**Subject: James A. Fitzpatrick Nuclear Power Plant
Docket No. 50-333
Follow-up Response to Request for Additional Information and Revision to
Proposed License Amendment to Safety Limit Minimum Critical Power Ratio
(SLMCPR)(TAC No. MC3391)**

ATTACHMENT 2 to JAFP-04-
ADDITIONAL INFORMATION IN SUPPORT OF ENO'S RESPONSE
TO QUESTION 1 OF REFERENCE 3 (RAI REGARDING SLMCPR)
(Non-Proprietary Version)

**Additional Information Regarding the
Cycle Specific SLMCPR for FitzPatrick Cycle 17**

Figure 1
 Reference Loading Pattern – FitzPatrick Cycle 16

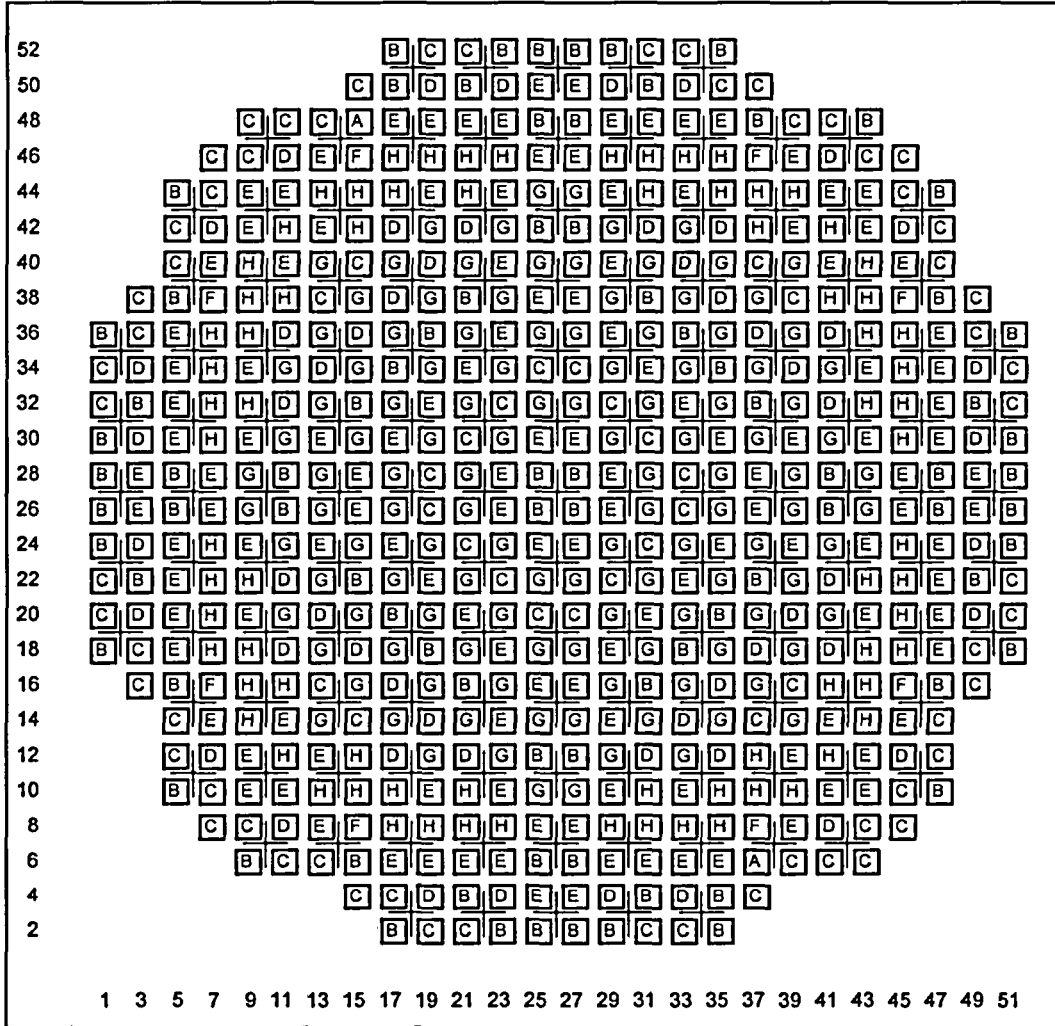
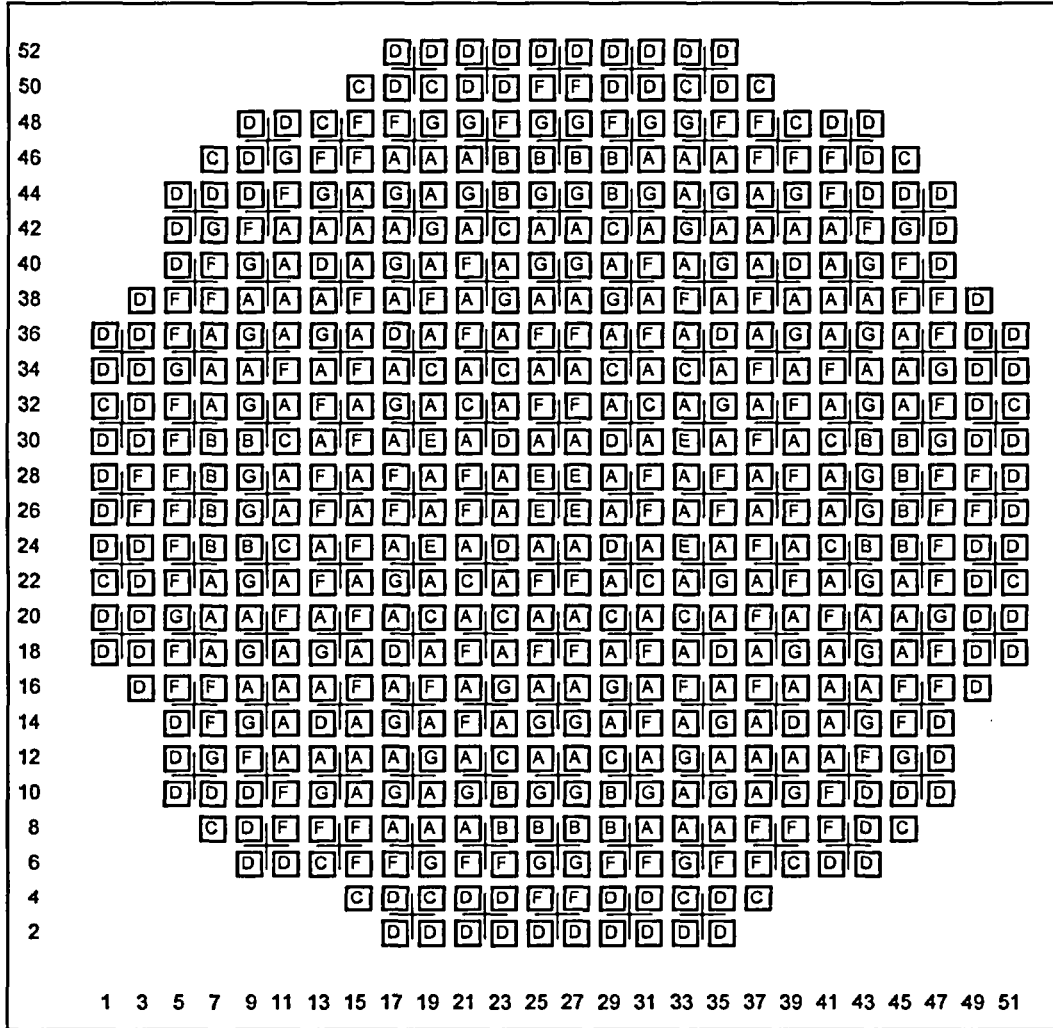
The core loading information for FitzPatrick Cycle 16 is provided in Figure 1. For comparison the core loading information for FitzPatrick Cycle 17 is provided in Figure 2. The impact of the fuel loading pattern differences on the calculated SLMCPR is correlated to the values of [[
